PLAN REVIEW SHEET

2017-179

Davis Development, Inc.

Bus stop pad detail

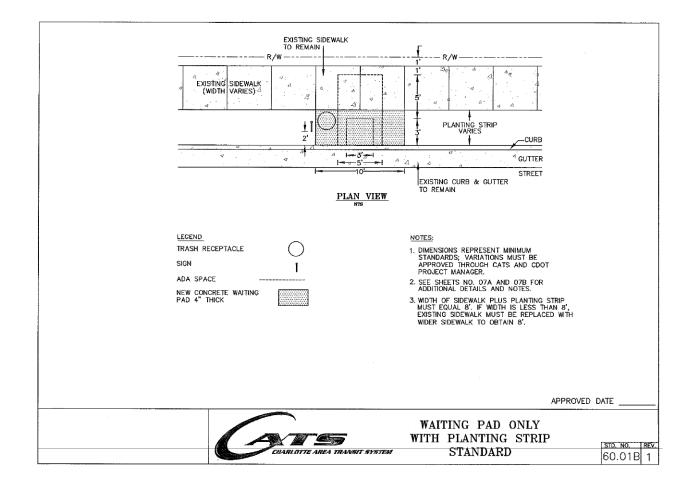
This site is along planned bus service from Concord Mills to the LYNX Blue Line. The Petitioner is requested to provide and construct a new waiting pad for a new bus stop on Mallard Creek Road along this site's frontage, where not conflicting with a right-turn lane.

Below is an image of the standard detail (60.01B) for the requested bus stop pad. Given the distance of the sidewalk running parallel to the roadway from the edge of Mallard Creek Road, a connecting five-foot sidewalk may connect the ten-by-eight loading pad at the curb. Permanent easement is requested, where dimensions exceed existing or proposed right-of-way limits.
